**JOINT REGIONAL PLANNING PANEL
SYDNEY EAST REGION**

JRPP No	2012SYE060
DA Number	201200225
Local Government Area	Marrickville
Proposed Development	To demolish the existing improvements, carry out preparatory site works and erect a mixed use development containing 7 retail tenancies, 206 residential dwellings and 163 car parking spaces, associated landscaping, drainage and related works.
Street Address	32-70 Alice Street, Newtown
Applicant/Owner	Al Maha Pty Ltd/The Registered Proprietors of SP 32809
Number of Submissions	269 submissions and two petitions containing 73 signatories.
Recommendation	Refusal
Report by	Harjeet Atwal, Senior Town Planner

Assessment Report and Recommendation

Figure 14.1a

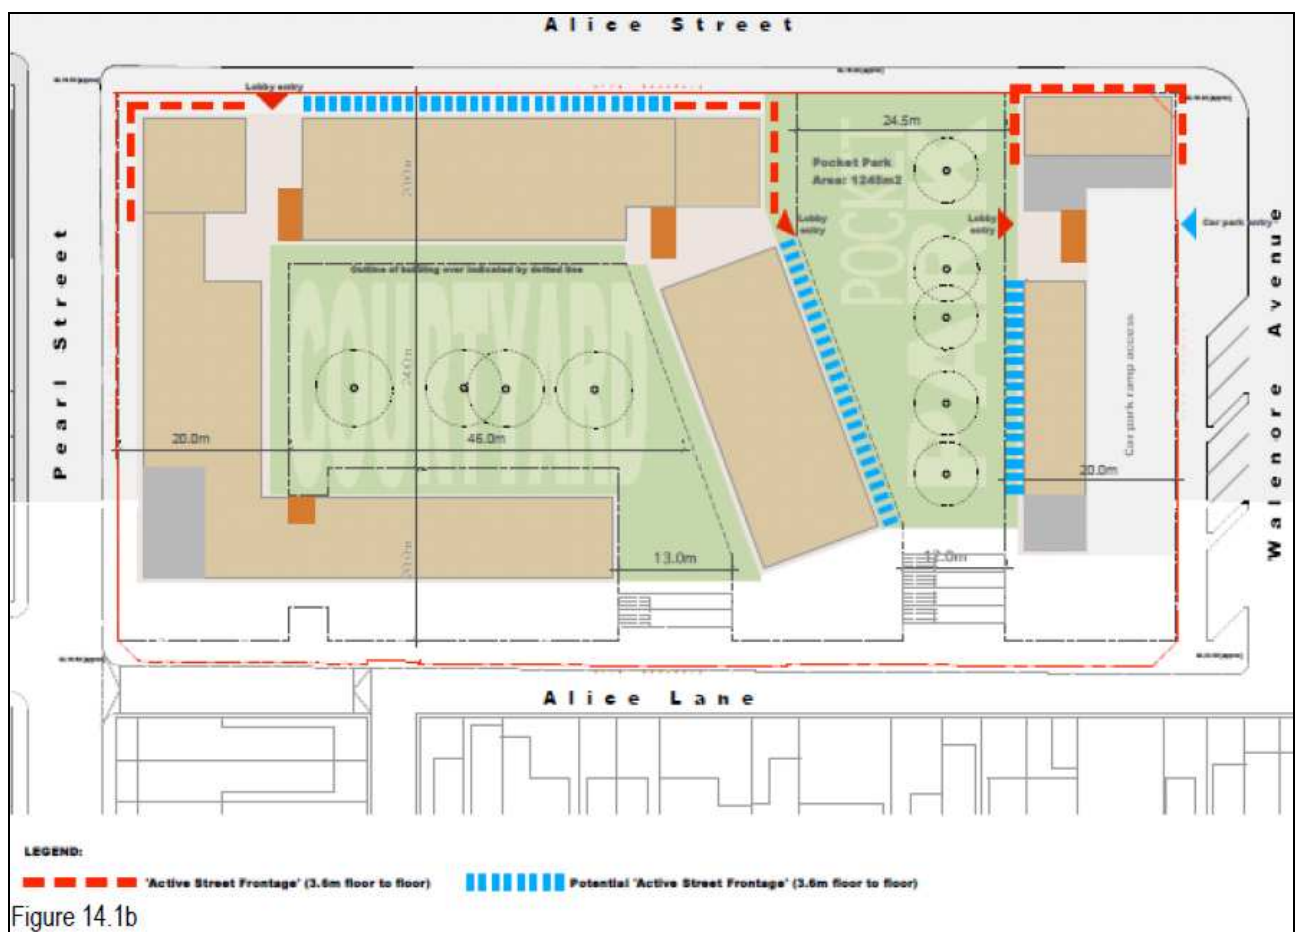
The proposed development conforms to the boundary setbacks prescribed in Figure 14.1a and Figure 14.1b.

The development provides active frontages and pedestrian links in accordance with Figure 14.1b.

The strategic context planning controls require the subject site to have one vehicular access from Walenore Avenue. The proposed development provides vehicular access for the commercial and residential component of the development from Pearl Street and an additional vehicular access for loading/unloading vehicles from Walenore Avenue. This is considered unacceptable for reasons discussed in this section of the report under the heading "*Parking (Part 2.10)*".

In accordance with Figure 14.1b, lobby entries are required to be directly located to the west and east of the Pocket Park. The proposed development locates a lobby entry off Walenore Avenue and a lobby entry along the southern façade of the block to the west of the Pocket Park.
